RESPONSE TO REQUEST FOR ADDITIONAL INFORMATION

APR1400 Design Certification

Docket No. 52-046

RAI No.: 246-8307
SRP Section: 09.02.02 – Reactor Auxiliary Cooling Water Systems
Application Section: 9.2.8
Date of RAI Issue: 10/14/2015

Figure 9.2.8-1 Turbine Generator Building Closed Cooling Water System Flow Diagram (1 of 4)

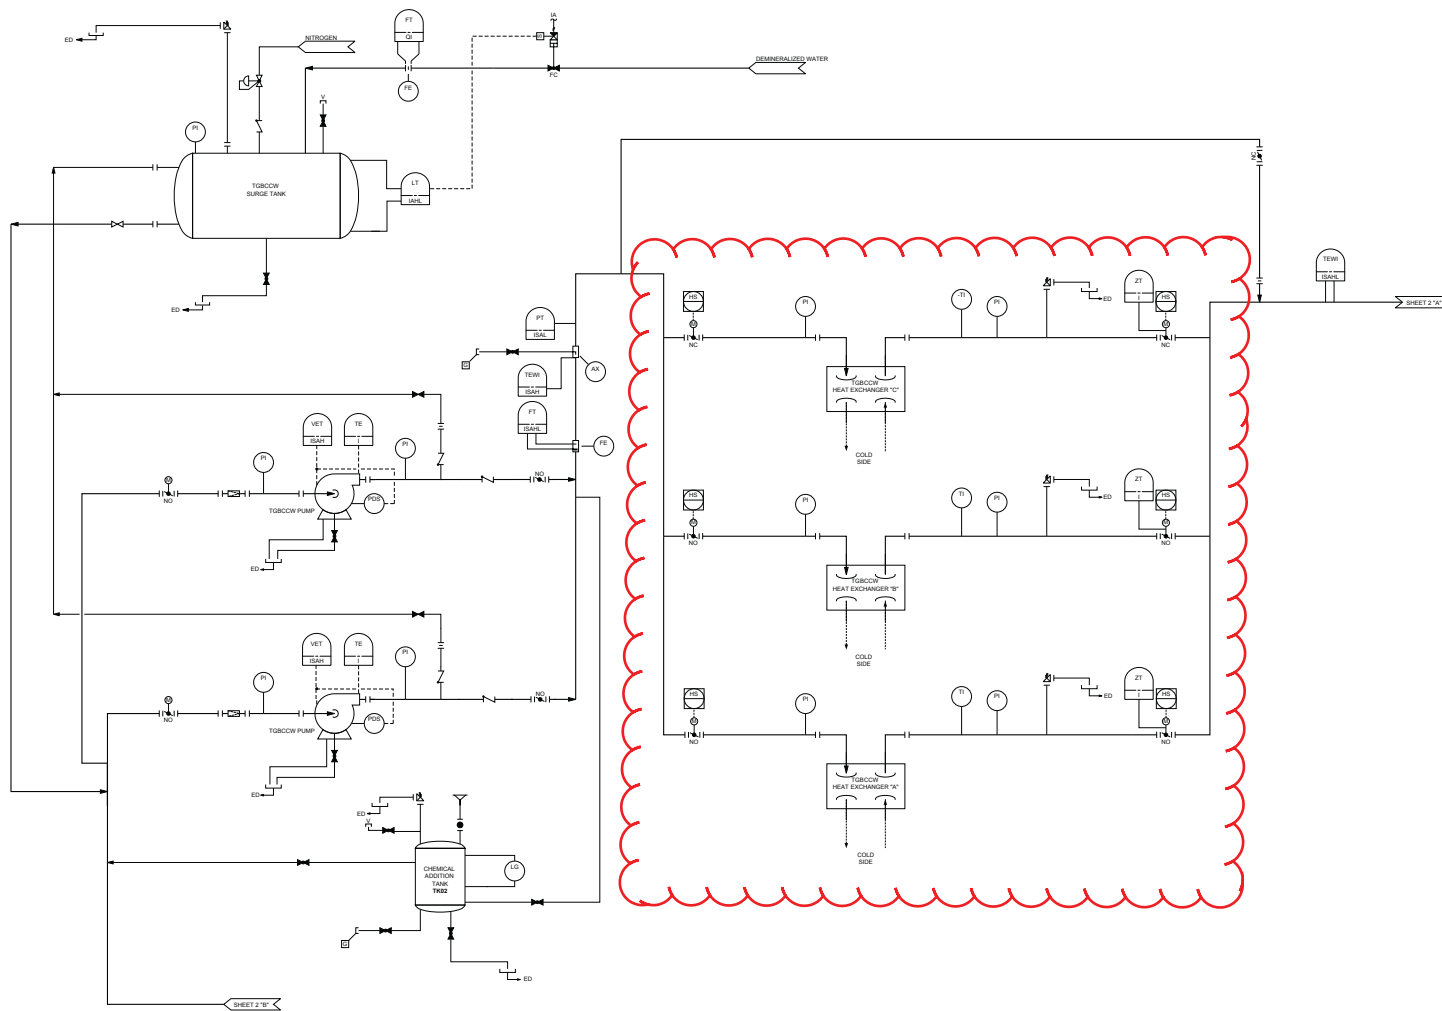
COL item 9.2(35) requires the COL applicant to maintain complete documentation of system design, construction, design modifications, field changes, and operations. The items addressed by this COL item, with the exception of the system design and design modifications, are post licensing actions that cannot be completed prior to the issuance of a COL license. Since the Turbine Building Closed Cooling Water (TBCCW) system is part of the design being certified, when referenced by a COL application, it will become part of the licensing basis for the COL. Design modification to the TBCCW in the COL application would likely be considered a departure and would be required to be identified as such in a COL application, and the NRC will review the change if required. Once a COL is issued, changes to the COL must be in accordance with 10CFR 52.98, "Finality of combined license; information requests," which provides information on what is required for changes to or departures from information within the scope of the reference design.

The applicant is requested to provide the basis for the COL item and to discuss why post licensing aspects such field changes and operations are included.

DCD Tier 2, OCL item 9.2(35) will be revised as indicated in the attachment to clarify what is required of the COL applicant.

DCD Tier 2, Subsection 9.2.8.2.1, 9.2.8.2.2, 9.2.8.2.3, 9.2.9.1, 9.2.9.2.1, 9.2.9.2.2, 9.2.9.2.3, 9.2.10, 12.4.3, Table 1.8-2 (14 of 29 and 21 of 29), Table 9.2.8-1, Figure 9.2.8-1(1 of 4), and Figure 9.2.9-1 will be revised as indicated in the Attachment.
